Access Compliance Report

Public Rights-of-Way

(Curb Ramps)

Intersection ID: 32085	Main Street: JERPOINT_ABBY_DR	Cross Street: LISMORE_CASTLE_CT	Location: NE
ADA ID: 9A645D9CBEF6	Ramp Type: BlendTrans1	Initial Pass/Fail: Fail	Overall Compliance: No
Severity Score: 10			
Codes/Mitigation Info/Possible Solution		Field Measurements/Component Compliance

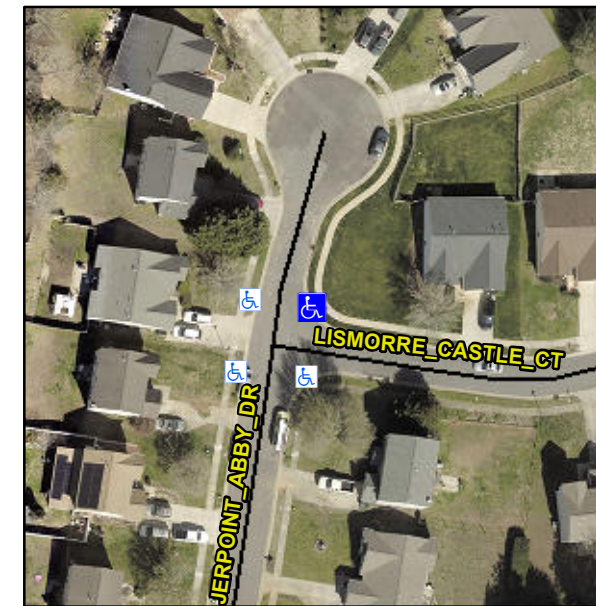
PROW/ADA:

R304.5.1, R304.5.3

Remove & Replace Curb Ramp With Two New Directional Ramps or Equivalent.
